SAMSUNG ELECTRONICS

SERVICE BULLETIN

Product :	DVDP	Bulletin No. :	98-DVD-E0001
Model :	DVD905	Bulletin Date :	MAR.23.1998
Buyer :	SEA	ECN # & Date :	MAR.23.1998

SUBJECT : DVD905 SYNC TROUBLE(TXG2548 TV)

Change:

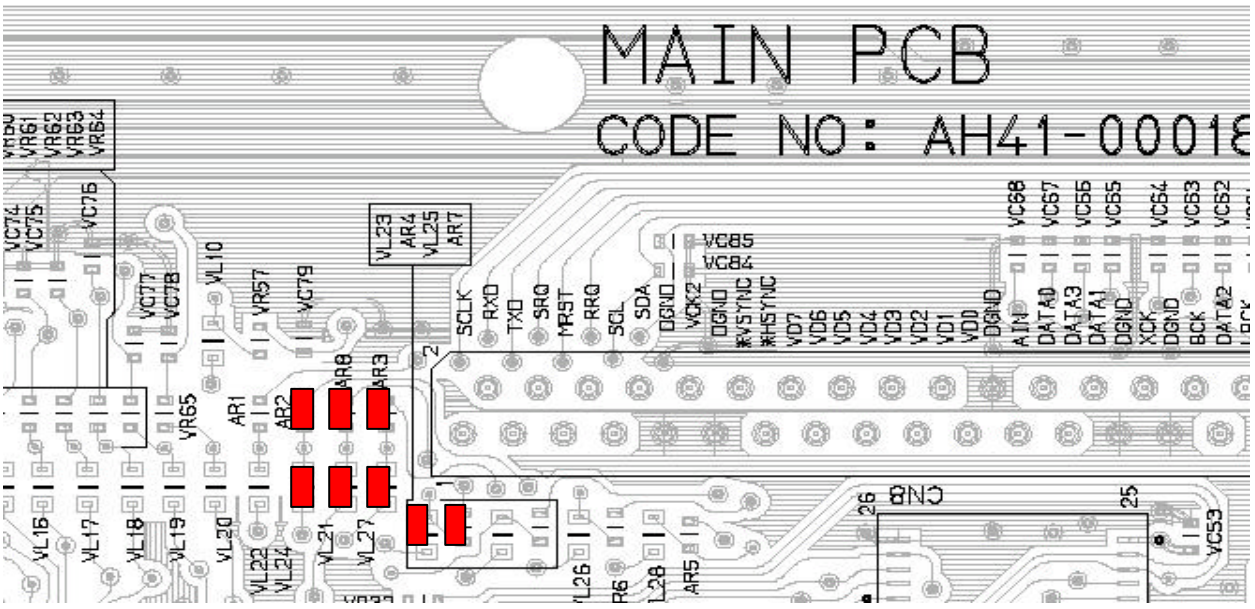
Background: (Symptom) **Audio signal is absent in Surround outputs.**

Reason: **Some elements are missing**

Solution: **Add missing parts**

Location No	OLD (before) Parts		NEW (changed) Parts	
	SEC Code	Description	SEC Code	Description
VL21			3301-000353	CORE-FERRITE BEAD;AB,2.0
VL23			3301-000353	CORE-FERRITE BEAD;AB,2.0
VL24			3301-000353	CORE-FERRITE BEAD;AB,2.0
VL27			3301-000353	CORE-FERRITE BEAD;AB,2.0
AR2			2007-000308	R-CHIP;10OHM,5%,1/10W,DA,
AR3			2007-000308	R-CHIP;10OHM,5%,1/10W,DA,
AR4			2007-000308	R-CHIP;10OHM,5%,1/10W,DA,
AR8			2007-000308	R-CHIP;10OHM,5%,1/10W,DA,
